## Determination 2018/048

# Regarding the refusal to issue a building consent for alterations of an existing building at 25 Courtenay Place, Wellington

This determination considers fire spread across a boundary in relation to an existing commercial building that is being altered. The determination considers how distance is measured to the relevant boundary for the purposes of considering fire spread to other property in order to satisfy the requirements of Building Code Clause C3—Fire affecting areas beyond the fire source.

Figure 1 Outline site plan (not to scale)

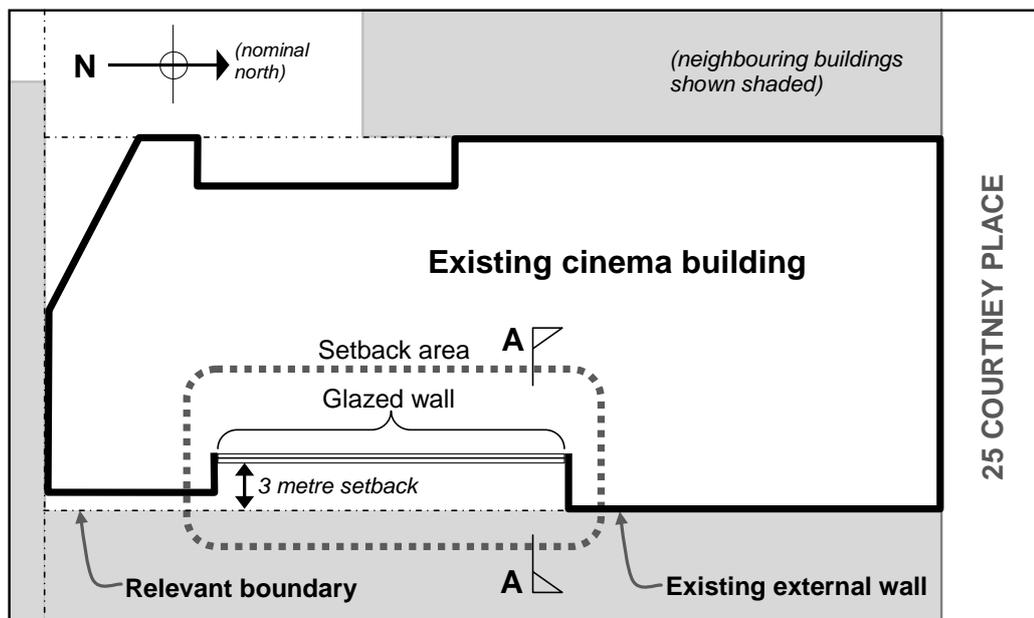
- 2.3 It is proposed to demolish part of the external wall and construct a glazed wall (“the glazed wall”), set back (“the setback area”) from the external wall and relevant boundary by 3.0m, to create an open decked space. Refer to Figure 1.

- 2.4 The setback area is annotated (east elevation drawing of the fire report only) as a mixture of protected (i.e. fire rated) and unprotected areas; ‘individual unrated areas up to 30% of the wall area, and permitted unlimited area of fire rated glazing’.

- 6.5.16 In the case of the proposed building work, the minimum distance to the relevant boundary is measured from the unprotected area (the glazed wall of the setback area). The minimum distance is 3.0m.

**Figure 2 Section A-A (not to scale)**

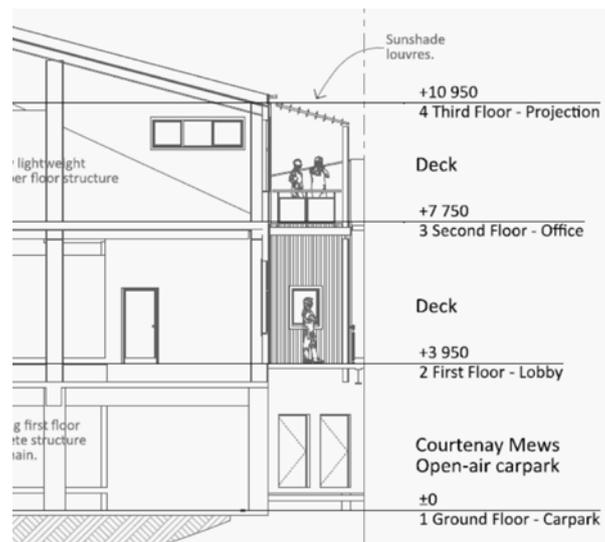
Please justify the 3M boundary distance when considering external spread of fire... we are not aware of a way to justify the use of that distance using the acceptable solution if each floor is a fire cell... The argument that the part of the building that keeps the weather out is the external wall by definition so can be considered the relevant distance to the boundary does not change the distance between the relevant boundary and the fire cell in question... council believes the compliance of the unrated glazing will need to be proved with calculations.

- The difference of view relates to “compliance with code clause C3 specifically C3.3 where the portion of the external wall of the firecell in question is off the boundary but the rest of the wall is on the boundary”.

- 6.5.14 Based on my discussion above, I take the view, and concur with the Ministry fire engineer in this matter, that the minimum distance is intended to be measured from the unprotected area to the relevant boundary.

6.4.6 Figure 5.3 of C/AS5 is as follows:

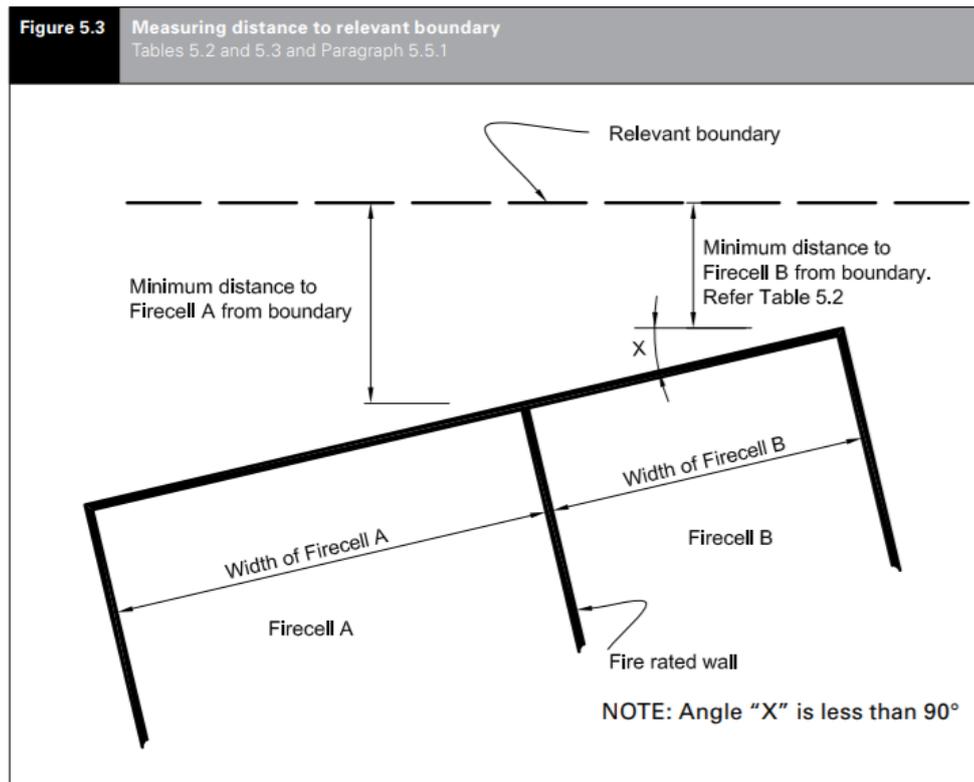
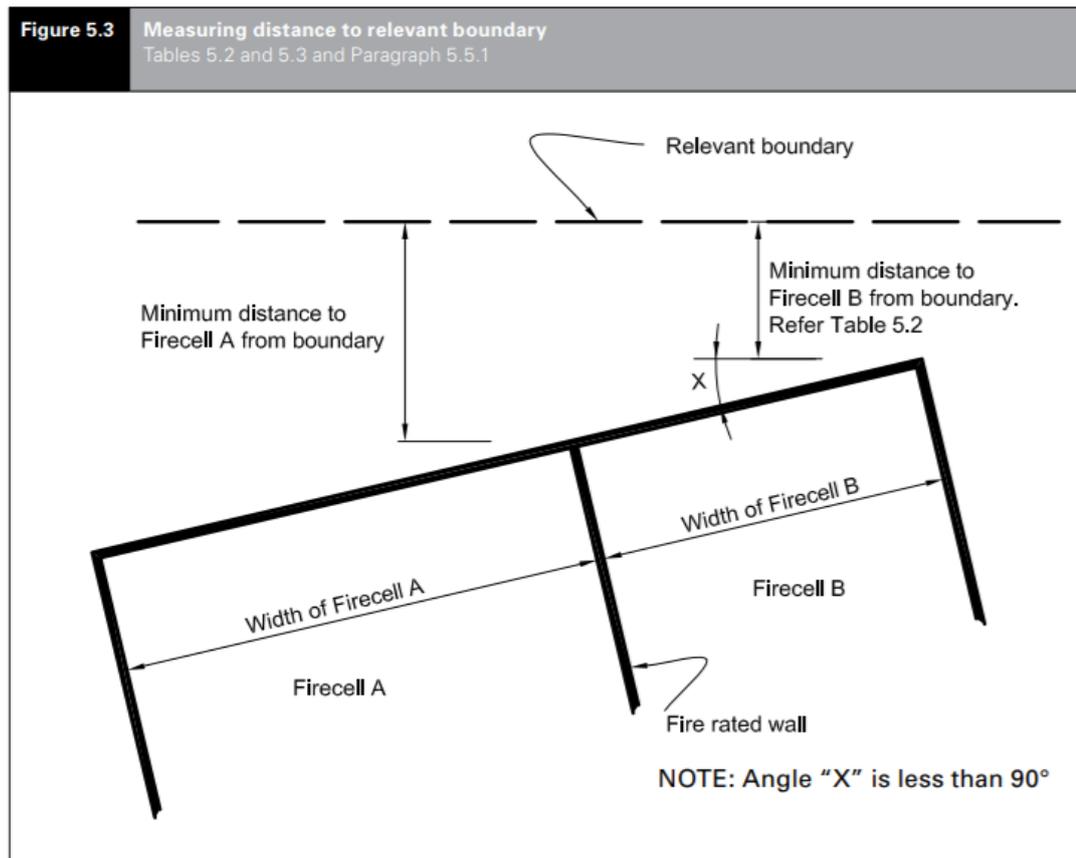
- C/AS5 Figure 5.3 ‘Measuring distance to relevant boundary’ requires the minimum distance of the firecell to the relevant boundary to be “the more onerous distance”.

- “Figure 5.3 [of C/AS5] suggests a ‘worst case’ scenario should be used when determining the separation distance from an unprotected area to the relevant boundary.” The closest point of the wall to the relevant boundary should be used.

4.2.4 The authority responded to the draft determination on 6 September 2018 saying that it accepted the determination’s findings but still considered that Figure 5.3 of C/AS5 was “misleading and is open to interpretation”.

6.4.7 The fire engineer is of the view the distance to the relevant boundary for the purpose of establishing the requirements of the setback area is measured from the unprotected area, being the glazed wall. Taking this approach, the distance is 3.0m.

6.4.8 The authority is of the view distance to the relevant boundary is measured from the nearest part of the firecell (i.e. the distance for which the most onerous requirements apply), to the boundary as shown in Figure 5.3. In this case, with the addition of the setback area, the firecell in shape resembles the top half of the letter 'H'. As part of the firecell (the existing portion of the wall) is located on the relevant boundary, the most onerous distance from the firecell to the relevant boundary is 0.0m.

- 6.5.4 Figure 5.3, the interpretation of which is in dispute, does not provide any explicit information regarding the location of unprotected areas within the firecell or external wall, or any guide to interpret when unprotected areas are at differing distances to the boundary (i.e. irregular shaped buildings or elevations with setbacks). Figure 5.3 is simply an illustrative example of how to determine the minimum distance of a wall to the relevant boundary, when the wall has multiple firecells along the elevation of the wall and where the wall is located at an angle to (i.e. not parallel with) the boundary.

- 6.5.6 Therefore, I take the view Figure 5.3 does not limit the Acceptable Solution to measuring the distance to the relevant boundary from the firecell, and does not include any limitation of wall geometry (i.e. elevations with setbacks). Rather Figure 5.3 is simply an illustrative example of the situation when an external wall has more than one firecell, or when the external wall is at an angle to the relevant boundary. The proposed building work is not comparable with the example illustrated by Figure 5.3 because the wall has one firecell, the proposed building work is parallel to the boundary, and has an irregular shaped elevation created by the setback area.

- 6.5.7 Where a figure illustrates a specific example and does not cover all the requirements set out in the text of the Acceptable Solution (as is the case with Figure 5.3) the text, as a more comprehensive description of the requirements, must take precedence.

- 6.5.15 In summary of my discussion above, I take the view that the Acceptable Solution permits the following: Where there is a collection of unprotected areas that face onto the same relevant boundary, and those unprotected areas are located at different separation distances to the relevant boundary, then the shortest separation distance from an unprotected area within a firecell to the relevant boundary is to be used.
